Delegated Report		Analysis sheet		Expiry Date:	07/12/2022
		N/A / attached		Consultation Expiry Date:	17/12/2022
Officer			Application Number(s)		
Leela Muthoora			2022/4428/P		
Application Address			Drawing Numbers		
9 Conybeare London NW3 3SD			Refer to decision notice		
PO 3/4	Area Team Signature	C&UD	Authorised Officer Signature		
Proposal(s)					
Erection of a single storey rear extension at first floor level to dwellinghouse (Class C3) (Associated applications at 24 Quickswood and 8 Conybeare)					
Recommendation(s):		Refuse planning permission			
Application Type:		Householder Application

1. Proposal

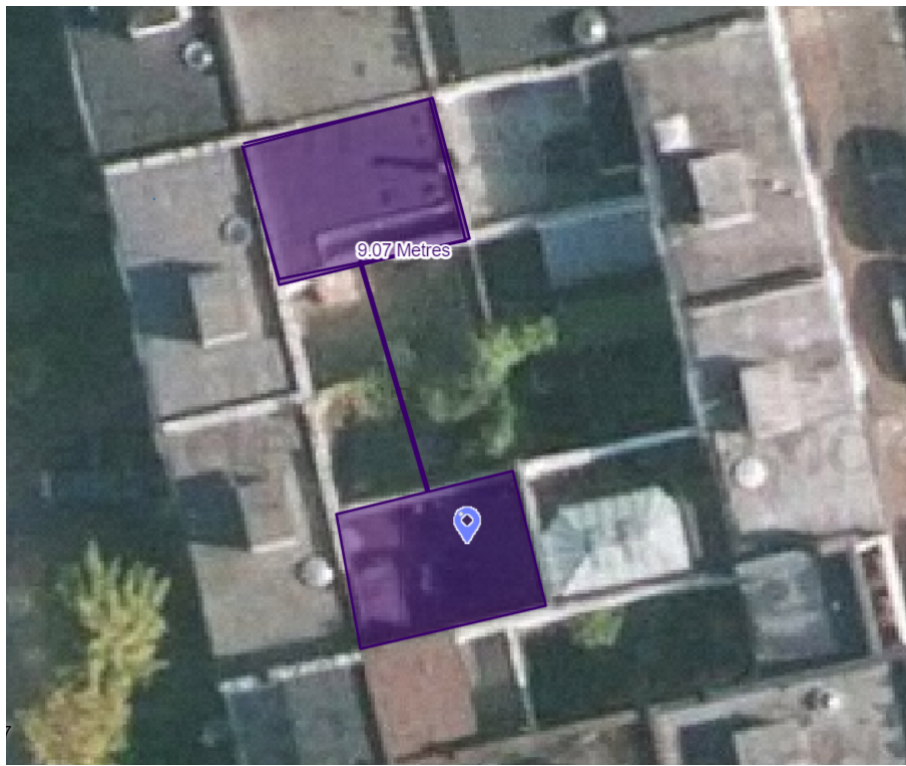
- 3.6. Due to the bulk and scale of the development, the proposal results in a dominant structure of a full additional storey which is no longer subordinate to the host building, is out of scale with the neighbouring sites and presents an overbearing massing to the enclosed gardens.

- 3.7. The accumulative impact of the same proposals at the neighbouring sites of 8 Conybeare and 24 Quickswood would result in excessive bulk and scale, which would no longer be subordinate to the host building or perimeter block of which it forms a part. The proposal would not respect the common pattern of rear extensions at neighbouring sites and considered together the proposed developments at numbers 24 Quickswood, 8 Conybeare and 9 Conybeare, would appear overly dominant in relation to number 26 Quickswood, in particular.

- 3.9. Overall, as a result of the excessive bulk and scale of the development, which is not subordinate to the host building, and the height, depth and width which do not respect the

common pattern of rear extensions at neighbouring sites, would harm the character and appearance of the host building and the perimeter block of which it forms a part. Therefore, the proposal is unacceptable in terms of design and would not comply with planning policy D1, Design or CPG Design and CPG Home Improvements.
